Construction Division
Additions & Alteration Charges Approval Form

GULMOHAR RESIDENCY

Details of Additions & Alterations

Flat No	507	Block no.	' G '
Flat Area	1360 sft	Type	Deluxe / Luxury
Buyer Name	PV Ravi Kiran		
Phone No.	984911875	Email

Changes in flooring:

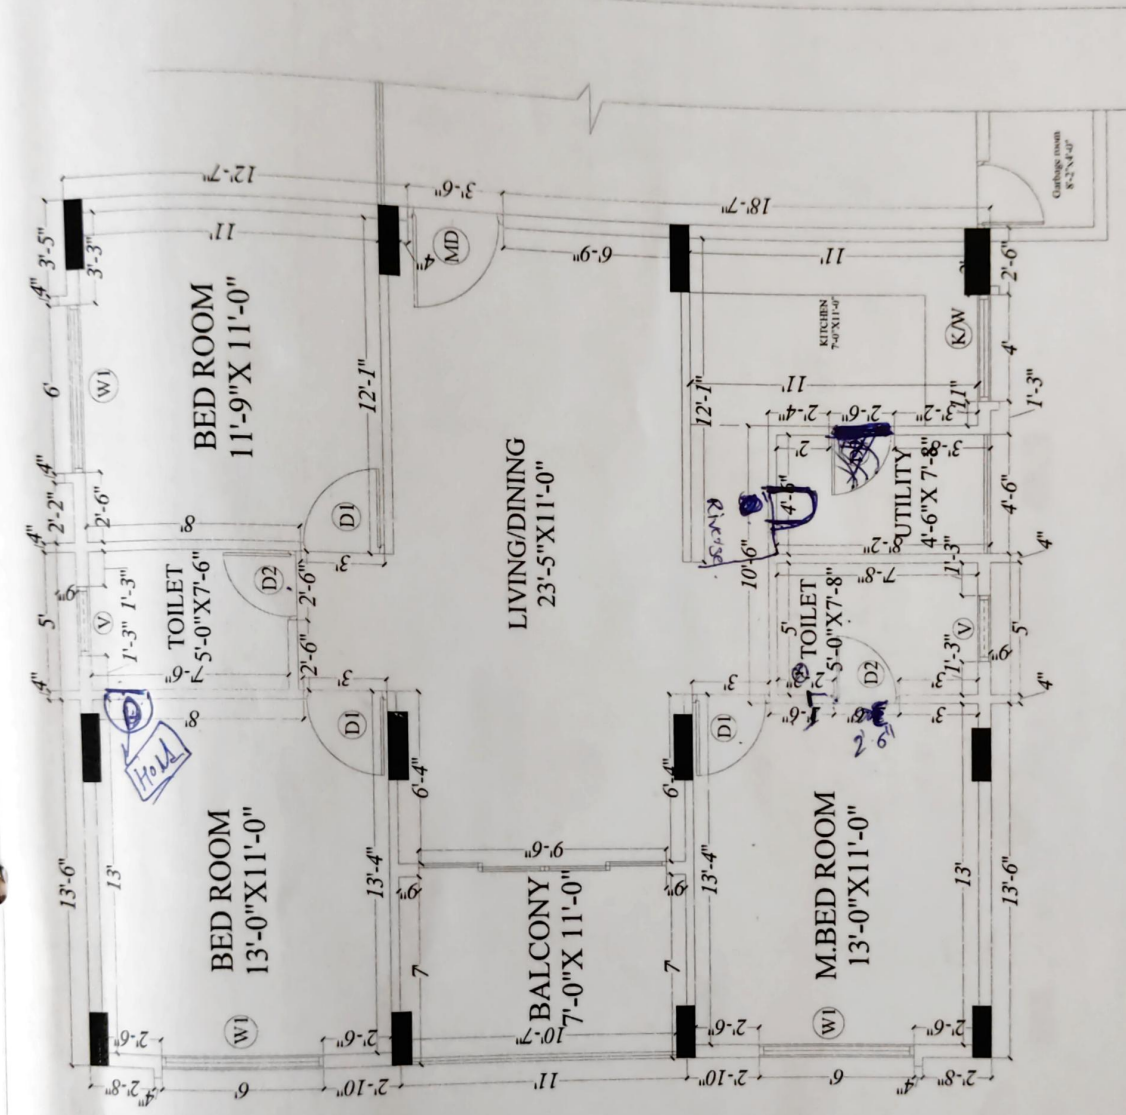
1) C.T. $\Rightarrow$ Luna

2) M.T. $\Rightarrow$ Malaysia

3) ultra sparkle $\Rightarrow$ Dalki $\Rightarrow$ wall vility
Mahalaja off $\Rightarrow$ floor vility.

4) Mahalaja off white $\Rightarrow$ Balcony.

5) Kitchen wall $\Rightarrow$ By customer
